LANDSCAPE CONSTRUCTION PLAN

LANDSCAPE  
FOUNTAIN  
PIPING PLAN  
& DETAILS

**TCR - THE VAUX**  
TRAMMELL CROW RESIDENTIAL

ASI 7

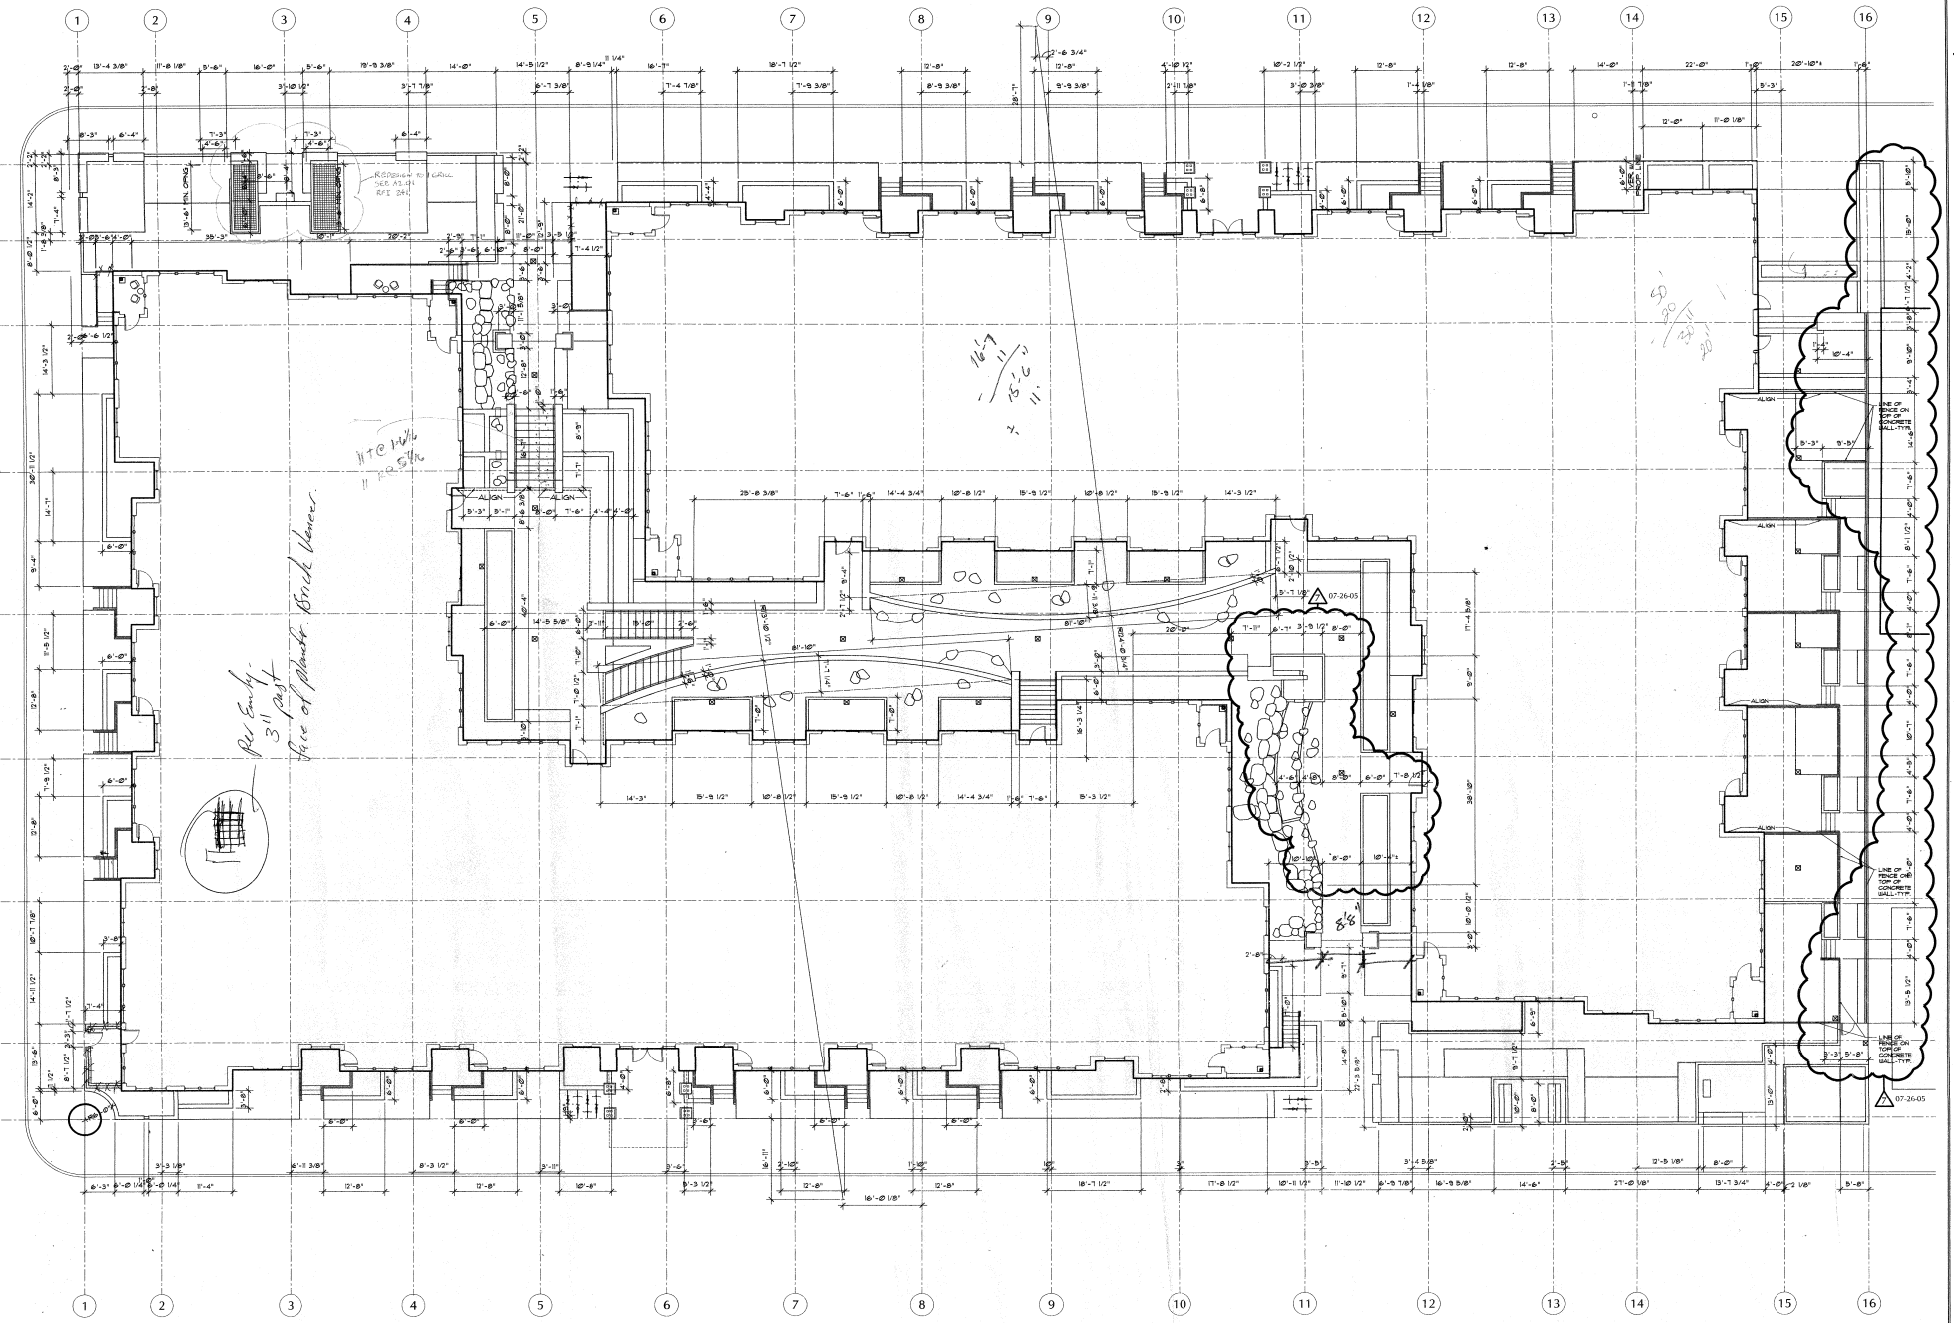
Per Emly -  
3" post  
face of plaster brick veneer.

170 MW  
plaster

**LANDSCAPE GRADING PLAN**

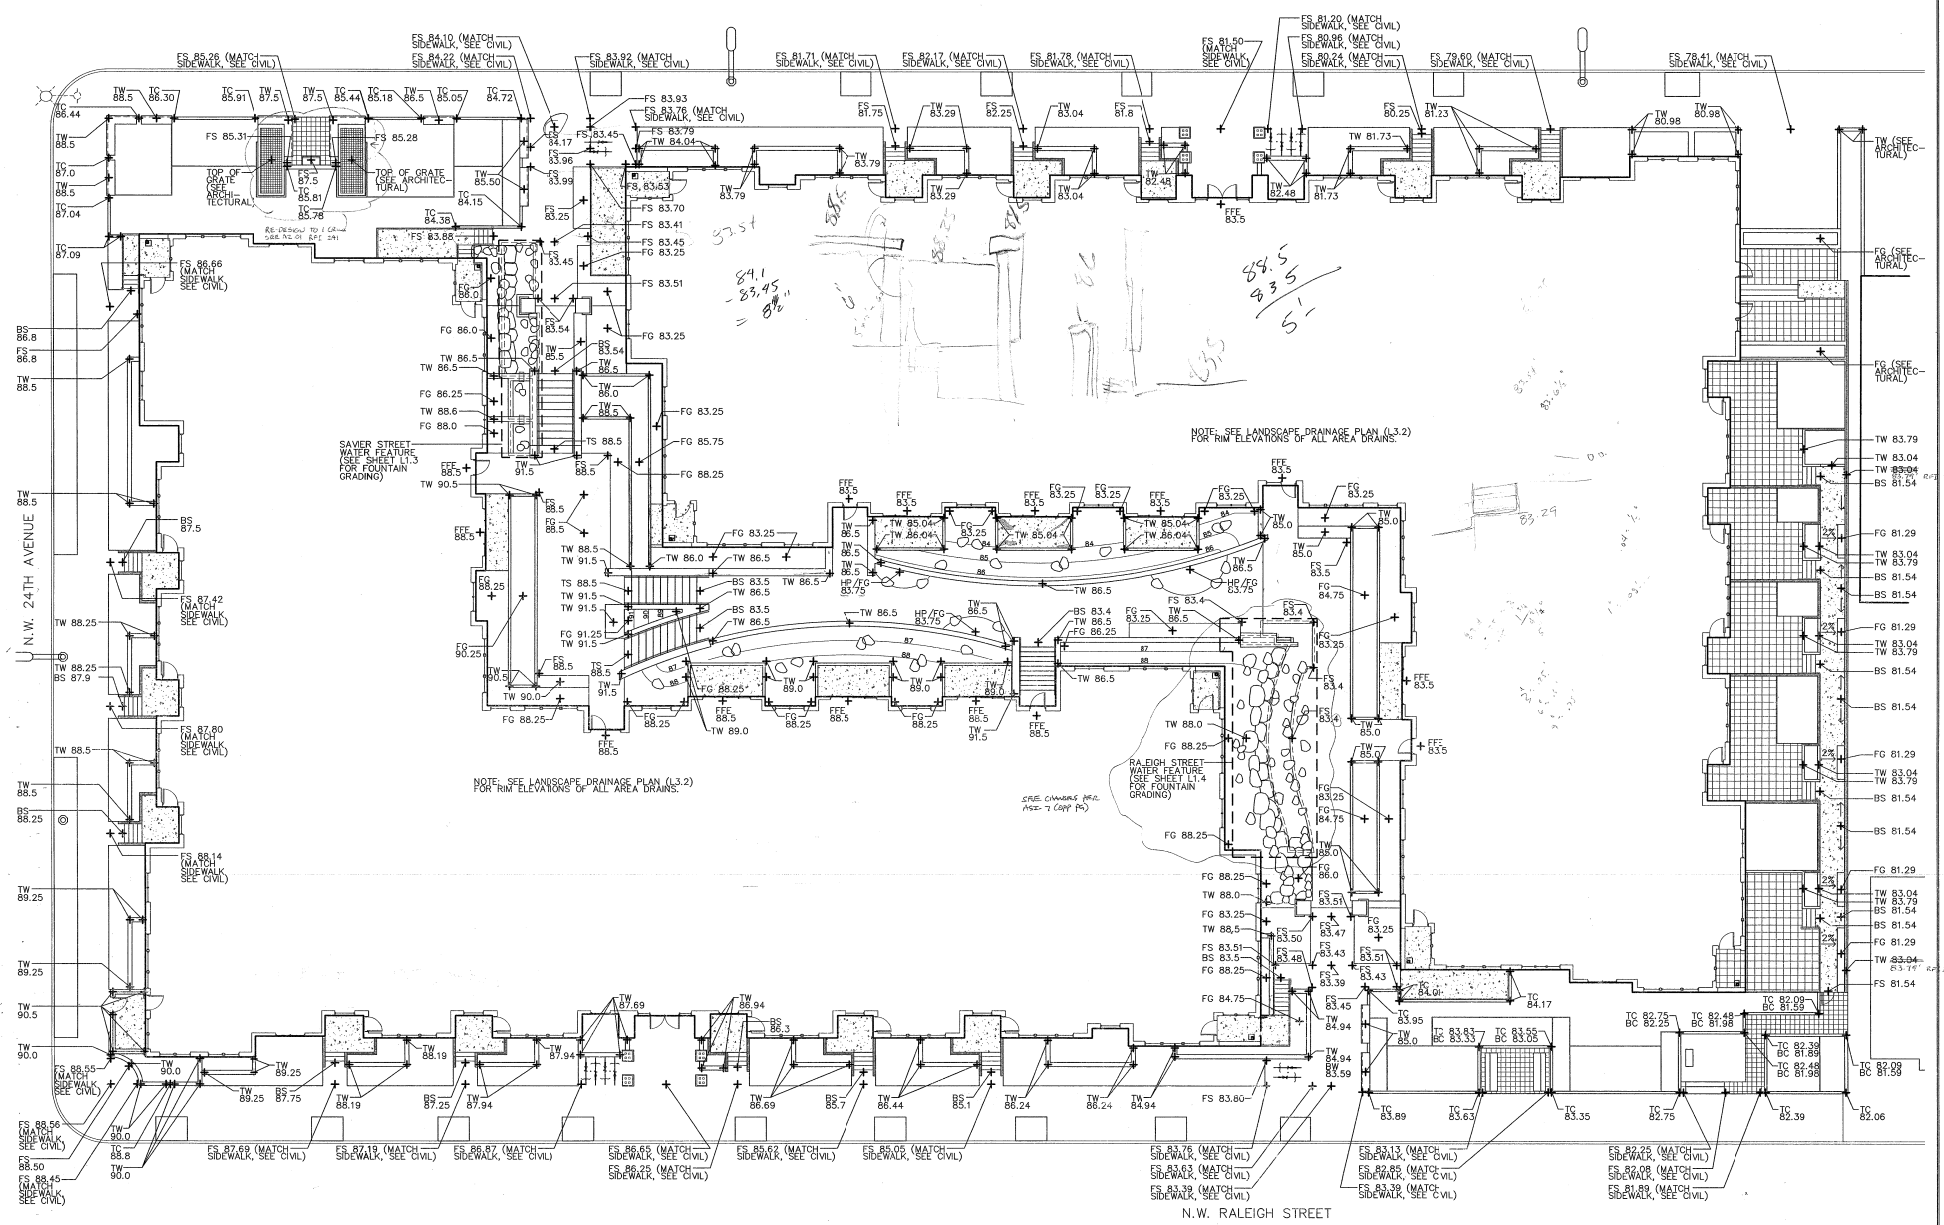
SEE CHANGE PER  
ADD-7 (COP. PG.)
